Letter of Determination

Site Address:	181 Fremont Street
Assessor's Block/Lot:	3719/010, 011
Zoning District:	C-3-O(SD) (Downtown—Office (Special Development))
Staff Contact:	Nicholas Foster, (415) 575-6167 or nicholas.foster@sfgov.org
Record No.:	2016-007743ZAD

Re: **181 Fremont Street – Waiver or Modification request pursuant to Planning Code Section 139(c)(3)(C)** (3719/011)

Subject: Proposed 181 Fremont Street Project – Response to City’s Comments Regarding Avian Collision Risk Assessment (HTH #3601-01)

Figure 2. Proposed curtain wall window dimensions.

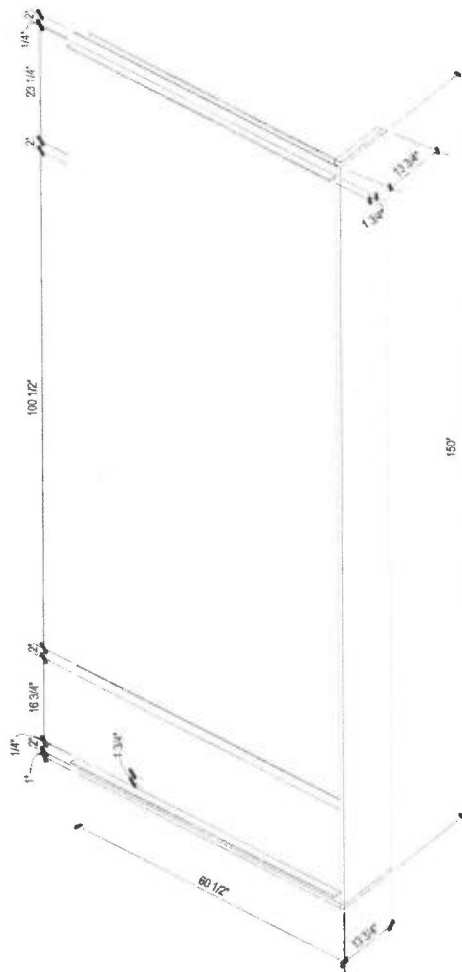
Comment #2: While the overall design of the building, with thick mullions and saw-tooth staggering of glazing, will help to disrupt reflections compared to a sheet of plain glass, it is still unclear what exactly the surface area will measure for the largest,

Comment #5: *Please provide additional elevation details of the glazing and saw-tooth design pattern at the level of the park and for 60' above so that we may verify what the largest segments of unbroken glazing will measure.*

Response: From park level to a height of 60 feet and above, the largest glass panel within each window will be 42 square feet (5 x 8.4 feet) in size (Figure 2). Adjacent windows will be offset by a 13.75-inch distance, producing a saw-tooth pattern. The 4-inch-wide aluminium mullions, the saw-tooth pattern of the curtain wall, and the shadows cast by the saw-tooth patterns and mullions will create a heterogeneous appearance that will be viewed by birds as a solid structure to be avoided even at relatively close distances. Figure 3 indicates how the proposed façade facing Transbay Park would appear from “treetop” level not far from the building face.

Response: Please see Figure 2 above for details on the dimensions of individual windows. Additional details regarding the proposed glazing and the saw-tooth design are attached.
